A REPAIR/24507

ON-SITE SEWAGE DISPOSAL SYSTEM HOWARD COUNTY HEALTH DEPARTMENT BUREAU OF ENVIRONMENTAL HEALTH

ADDRESS: 7519 Flamewood Drive PROPERTY OWNER: Scott Deiter

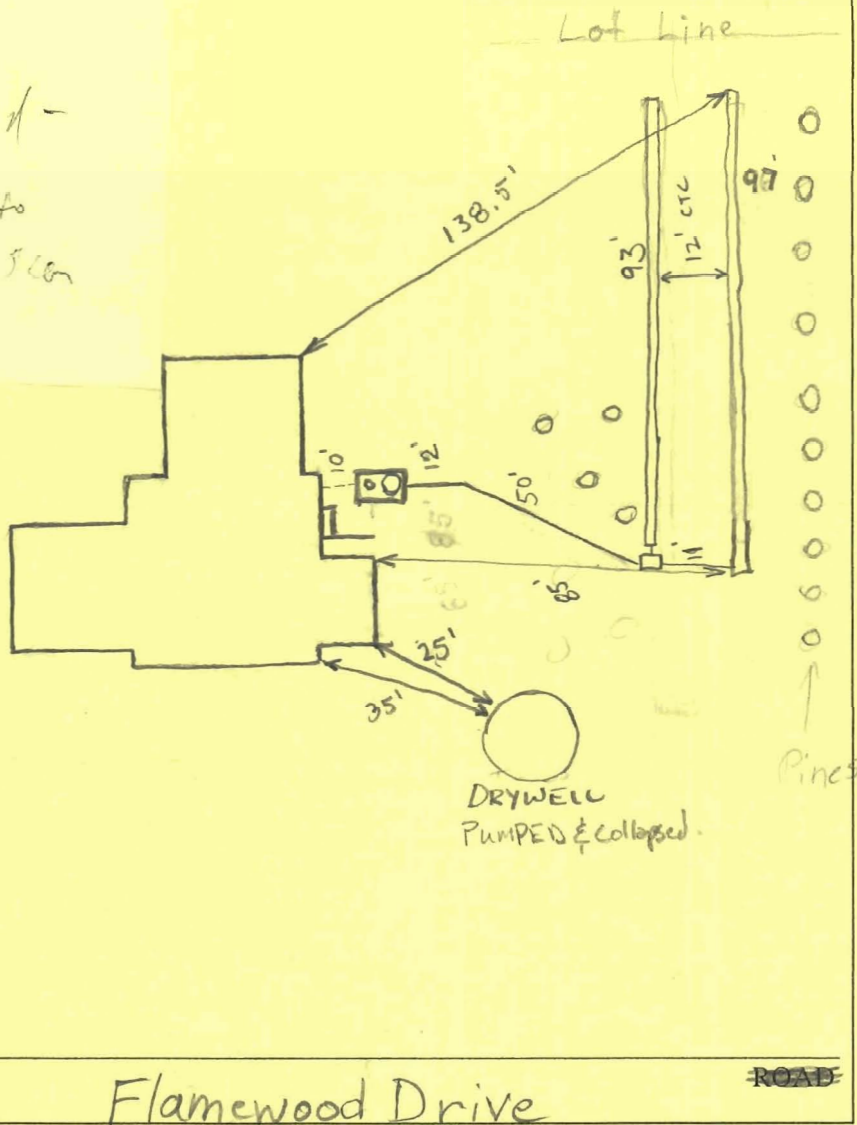
PRE-CONSTRUCTION 10/27/05 Install 2 - 93' trenches on contour in area shown above. Pump out and fill drywell with dirt. (BB)

INSTALLATION 11/1/05 Lower Trench open depth, Inlet, contour OK, OK to cover all but ends when finished. Drywell being pumped. 11/2/05 System complete, OK to backfill everything. Drywell filled in. (GTC)
